The amendment revises the Technical Specifications to (1) incorporate new maximum average planar linear heat generation rate (MAPLHGR) curves for two new barrier fuel types to be used in the upcoming operating Cycle 8 and approve extended MAPLHGR curves for assembly average burnup of 45,000 MWD/ST for certain fuel types that will comprise part of the core for the upcoming operating Cycle 8; (2) change the calibration and functional test frequencies for certain specific instrumentation that is being modified into analog trip systems; and (3) incorporate appropriate Technical Specifications for operation with the newly modified scram discharge system.

QUAD CITIES NUCLEAR POWER STATION, UNIT 2  
AMENDMENT TO FACILITY OPERATING LICENSE

Amendment No. 86  
License No. DPR-30

SAFETY EVALUATION BY THE OFFICE OF NUCLEAR REACTOR REGULATION  
SUPPORTING AMENDMENT NO. 86 TO FACILITY OPERATING LICENSE NO. DPR-30

Figure 3.5-1  
(Sheet 1 of 6)

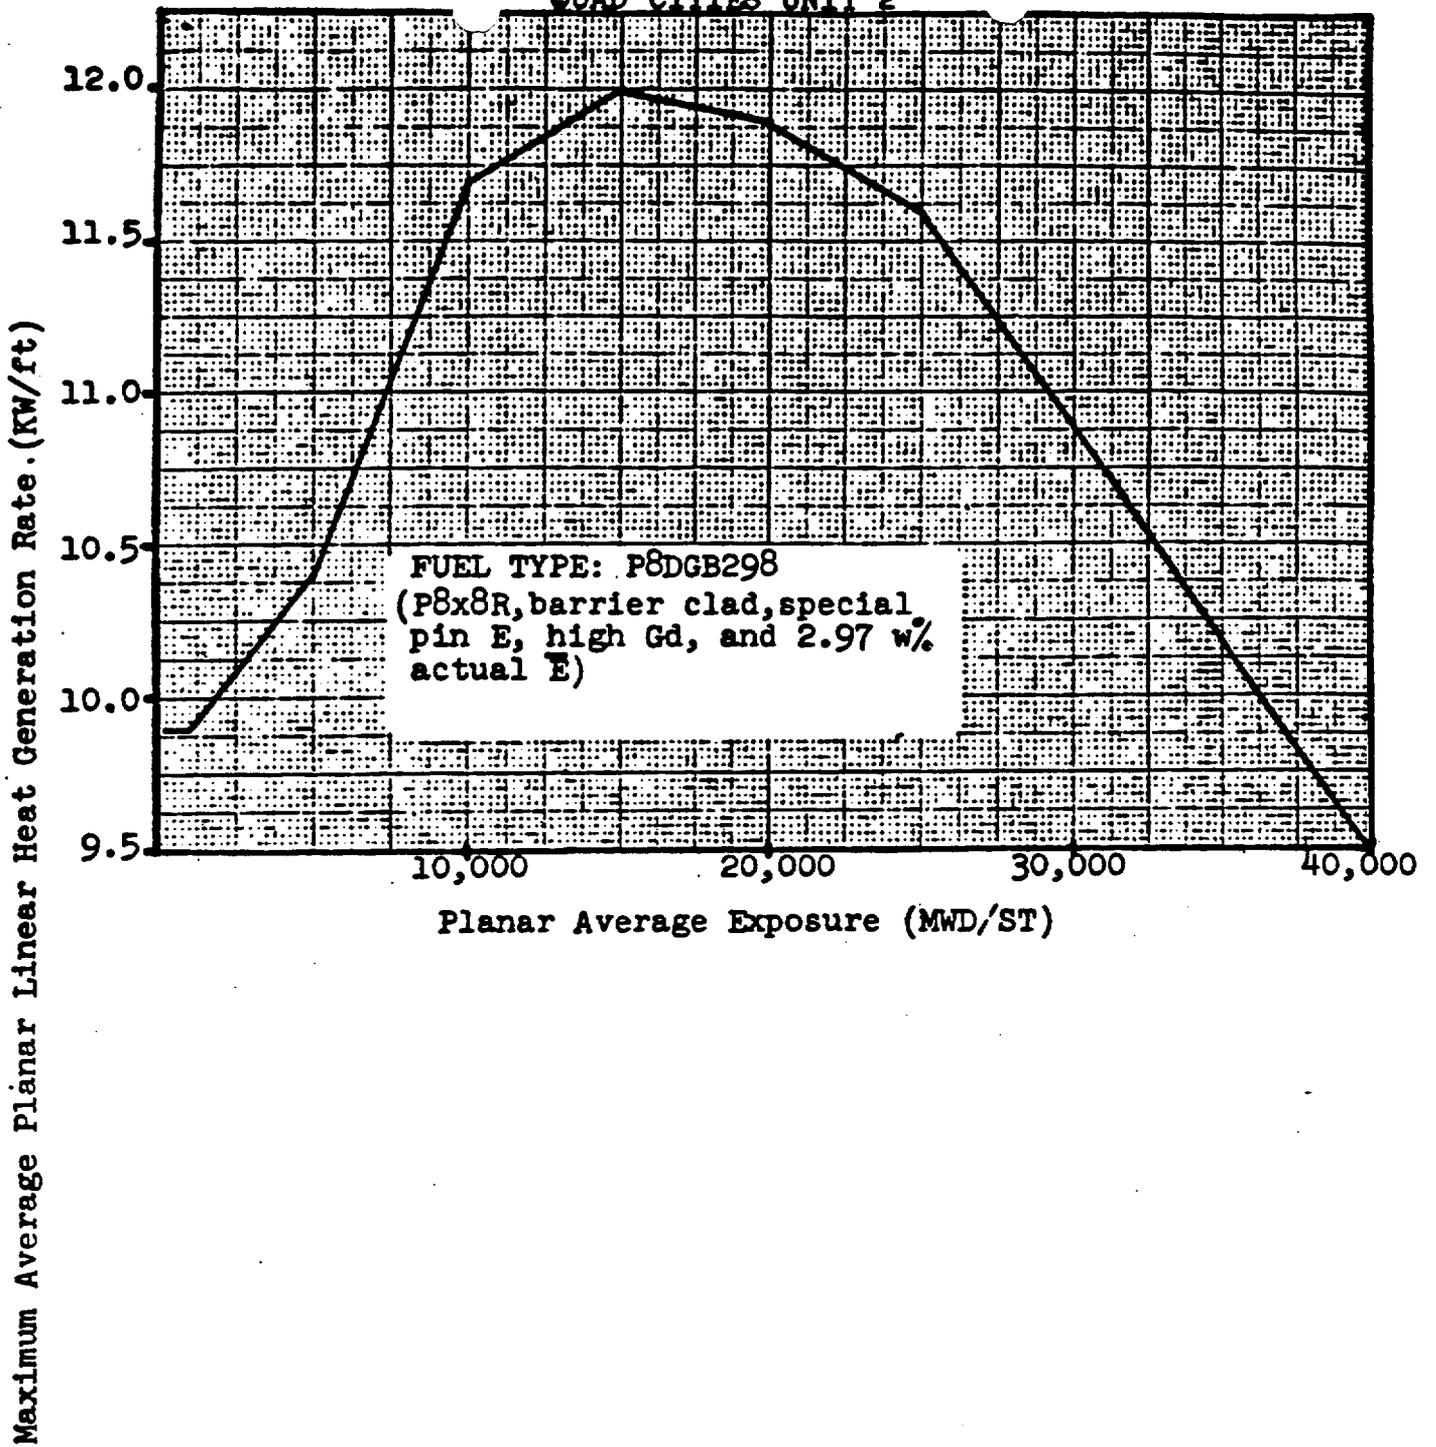
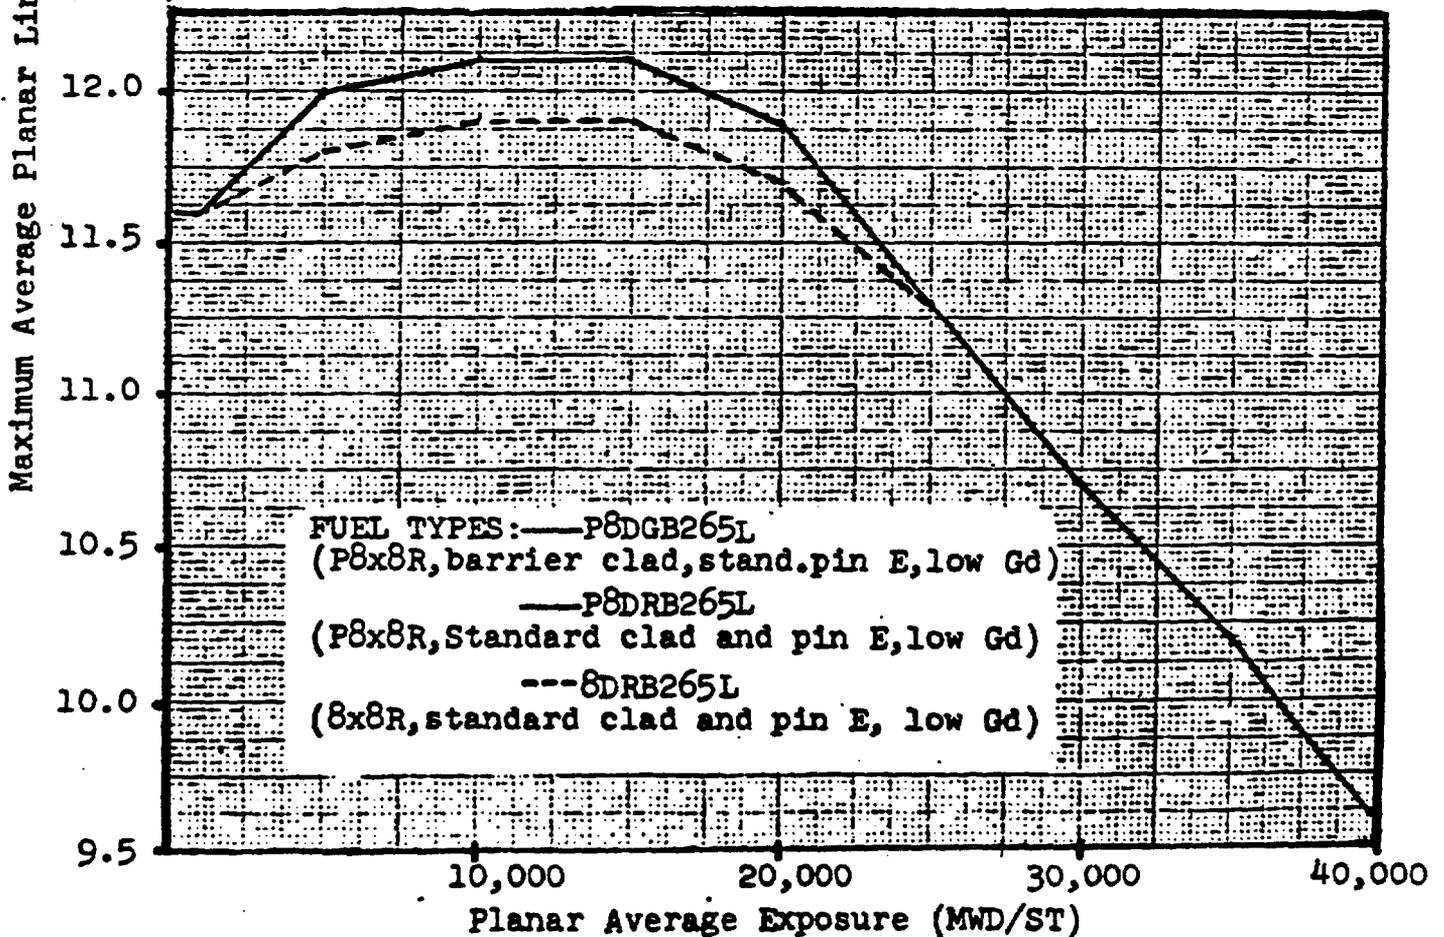
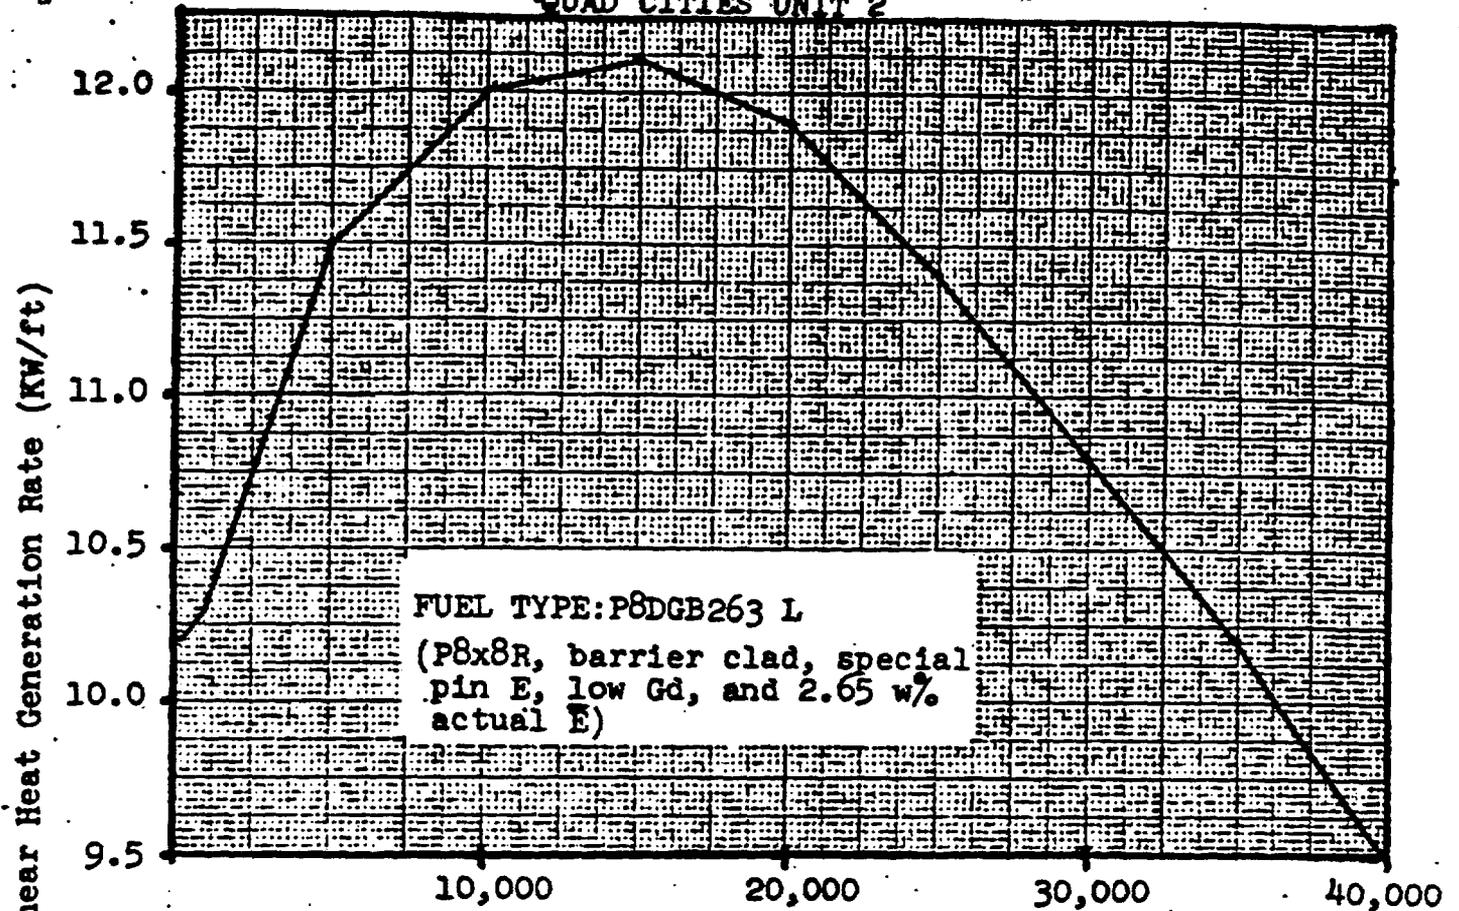
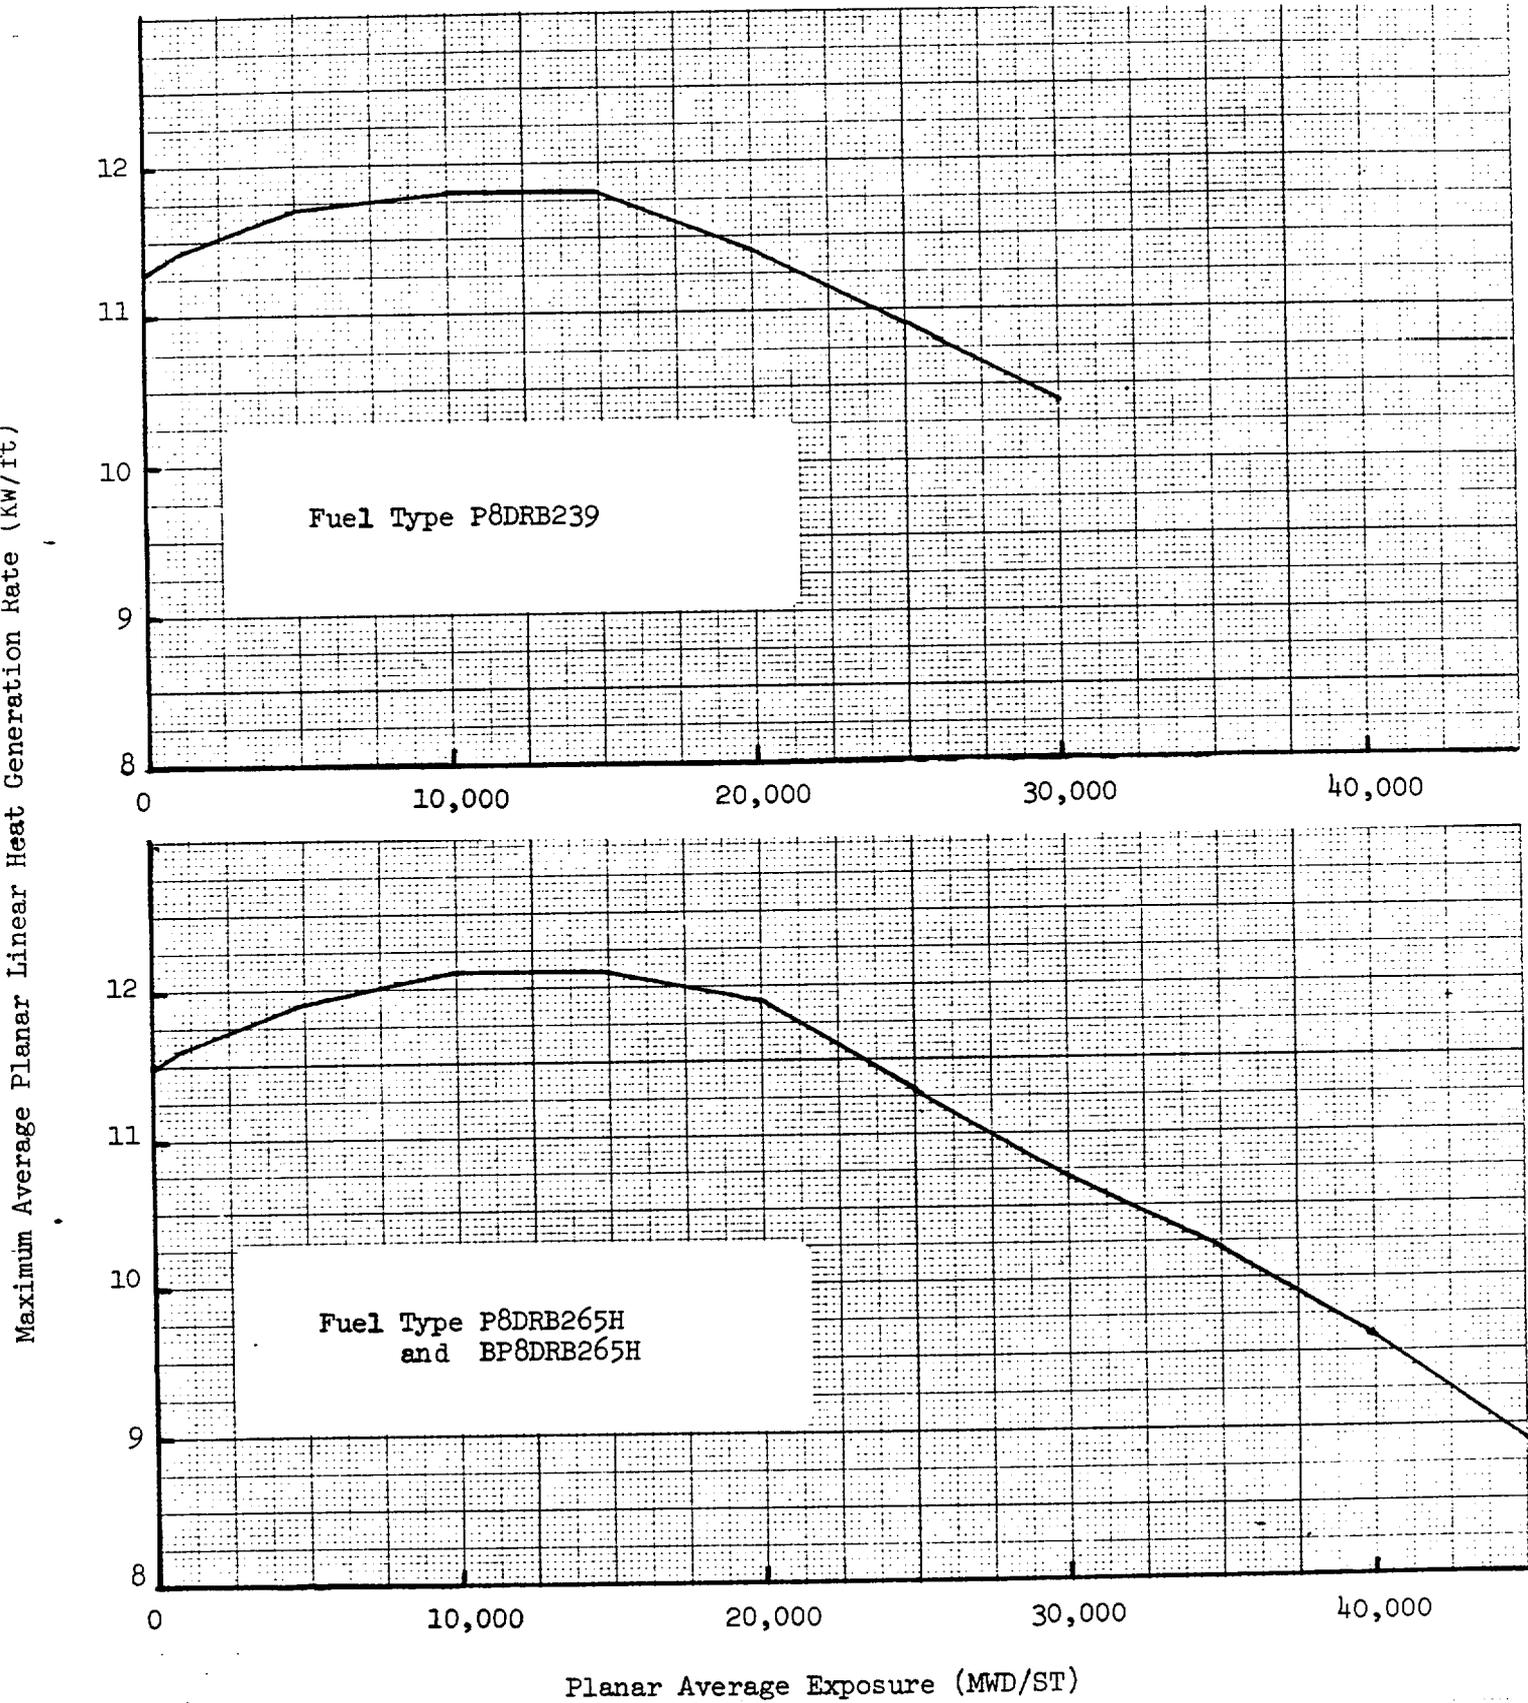
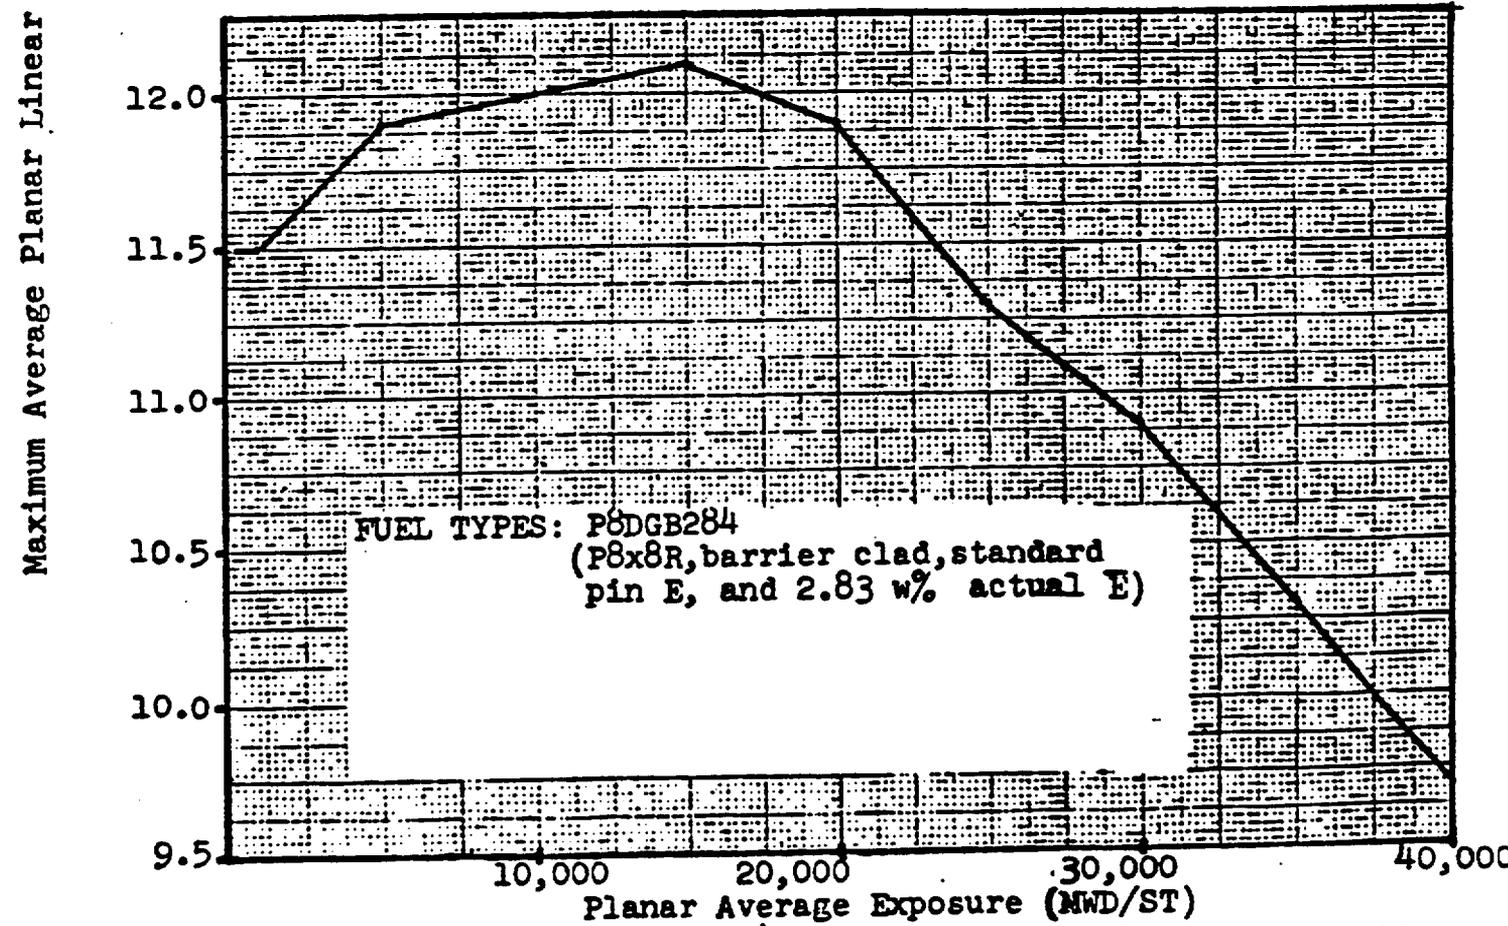
By letters dated January 3 and February 4, 1985, Commonwealth Edison Company (CECo, the licensee) proposed changes to the Technical Specifications (TS) for Quad Cities Unit 2 (see References 1 and 2). These changes would (1) incorporate new maximum average planar linear heat generation rate (MAPLHGR) curves for two new barrier fuel types to be used in the upcoming operating Cycle 8, and approve MAPLHGR curves for assembly average burnup to 45,000 MWD/ST for certain fuel types contained in the core during upcoming operating Cycle 8; (2) change the calibration and functional test frequencies for certain specific instrumentation that is being replaced with analog trip systems; and (3) incorporate appropriate TS for operation with the newly modified scram discharge system.

The reference document containing the emergency core cooling system (ECCS) analysis for Quad Cities Unit 1 and 2 (as well as Dresden Units 2 and 3) has previously been approved by the NRC staff and continues to be the basis for MAPLHGR limits for all fuel types used in these units (Reference 4). This reference document has been updated as appropriate for other fuel types by issuance of Errata and Addenda (E and A) to Reference 4. Barrier fuel types BP8DRB282 and BP8DRB283H, to be used in the core during the upcoming operating Cycle 8 for Quad Cities Unit 2, have previously been approved for use in Quad Cities Unit 1 (Reference 3) and are currently being used in operating Cycle 8 of that nuclear unit. The licensee's application (Reference 2) provides E and A No. 13 to the previously approved ECCS analysis for Quad Cities Unit 1 and 2 (Reference 4). As did E and A No. 12 for Quad Cities Unit 1, so does E and A No. 13 to Reference 4 show that the MAPLHGR curves for fuel types BP8DRB282 and BP8DRB283H satisfy the requirements of the 10 CFR 50.46 acceptance criteria, and are appropriate for incorporation into the TS for Quad Cities Unit 2, so that the licensee's proposal to change the TS to incorporate those MAPLHGR curves into the TS is acceptable.

The licensee's application (Reference 2) also contains a request to approve an extension of MAPLHGR limits to assembly average burnup of 45,000 MWD/ST for two fuel types already in the core. By E and A No. 10 to Reference 4, provided in the licensee's application (Reference 2), the licensee supports an extension to MAPLHGR curves from 30,000 to 45,000 MWD/ST for fuel types P8DRB265H and BP8DRB265H. These limits were generated by method previously approved and having general applicability for MAPLHGR limit determination (Reference 5). In response to NRC staff concerns that the possible effects of enhanced fission gas release were not adequately considered in the fuel performance model, GE requested that credit for approved but unapplied ECCS evaluation model changes and calculated peak cladding temperature margin be used to avoid MAPLHGR penalties at high burnups (References 6 and 7). This proposal was found acceptable (Reference 8) provided that certain plant-specific conditions were met. As documented in the licensee's application (Reference 2), the General Electric Company (GE)-produced supporting reference document demonstrates the applicability to Quad Cities Unit 2 operating Cycle 8. Further, the staff has investigated potential changes in the radiological consequences of the fuel handling accident (the design basis accident) due to the possible involvement of extended burnup (as high as 45,000 Mwd/MT) fuel in the accident scenario, and concludes that new radiological consequences would not be in excess of the Standard Review Plan (SRP) guideline value of 75 REM to the thyroid. On the basis of the foregoing considerations, the extended MAPLHGR limits for the fuel types cited are acceptable.
